CITY OF WESTFIELD, IN
Advisory Planning Commission Meeting Agenda_01_05_2015

BOARD OR COMMISSION: Advisory Plan Commission (APC)

MEETING DATE: Monday, January 05, 2015 at 07:00 PM

DRAWING NUMBER
C2.0
SHEET 5 OF 2

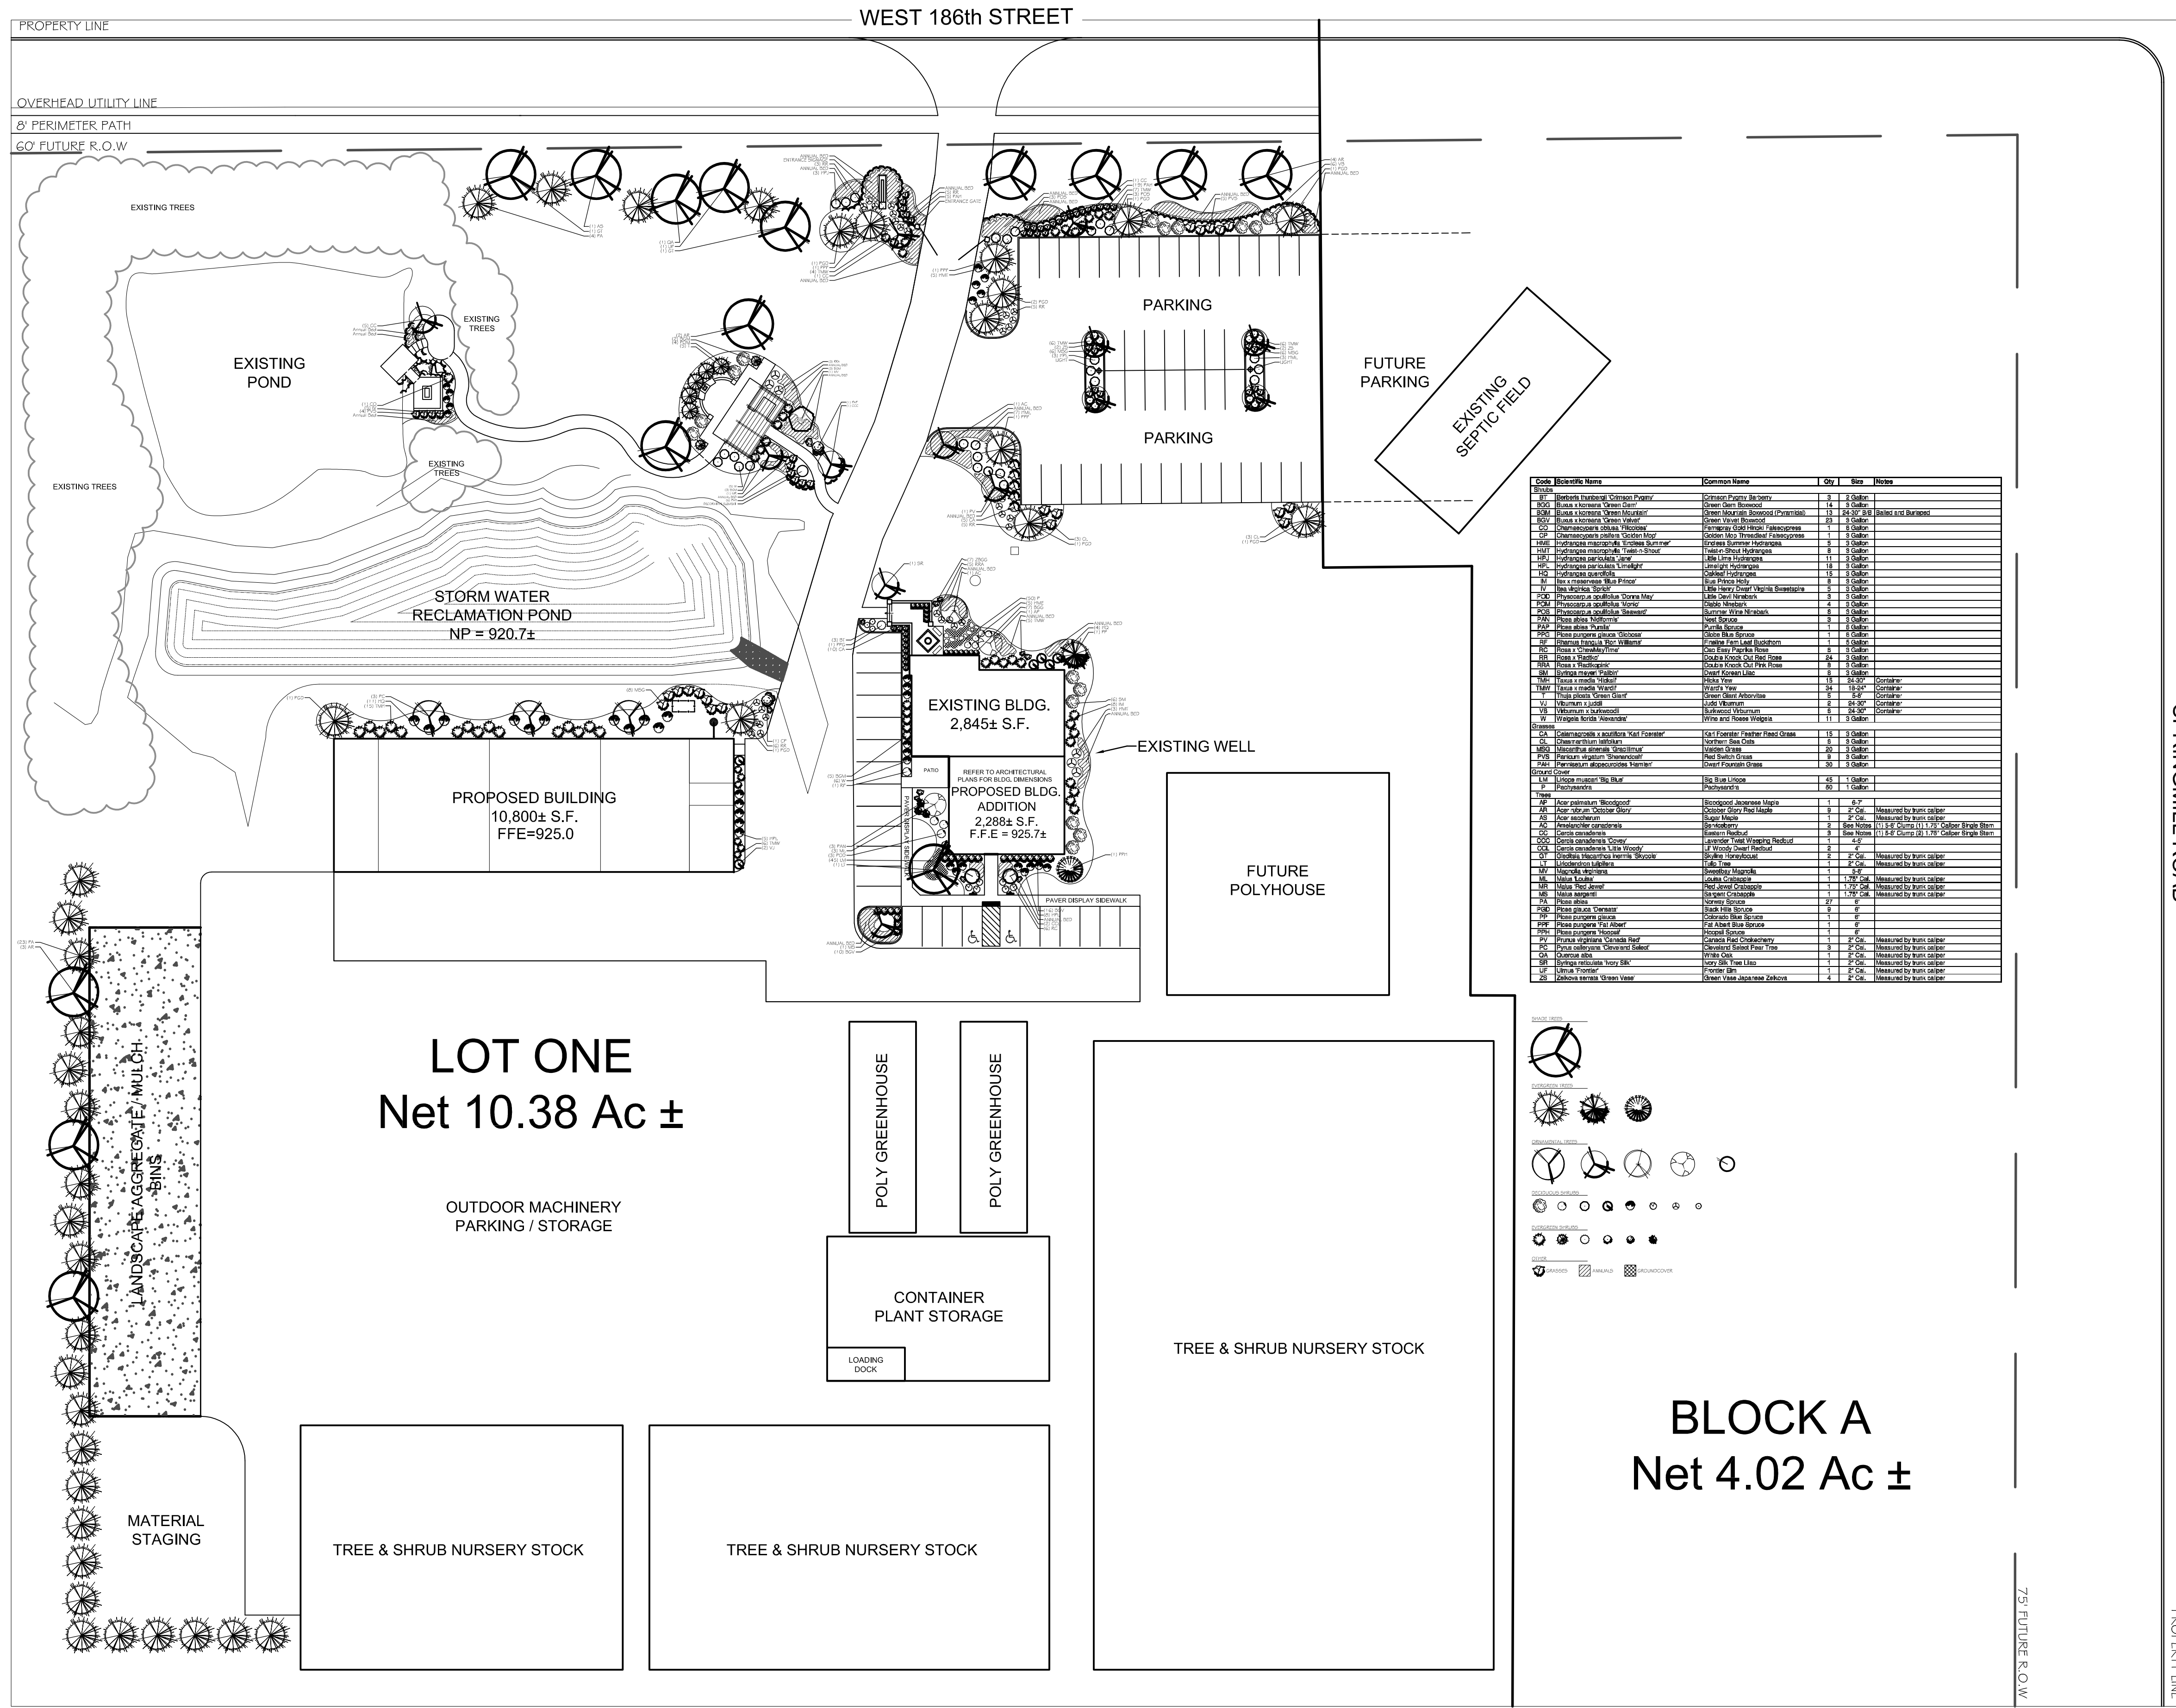
Comment(s): The Department is working with the petitioner to: (1) adjust view to show the entire site in the Overall Development Plan (C2.0) because the south property line is not visible; (2) change title of C2.0 to read "Detailed Development Plan;" and (3) pursuant to item (m) above, show proposed buildings in cross-hatching to distinguish them from those currently existing on site and indicate this cross-hatching in the legend.
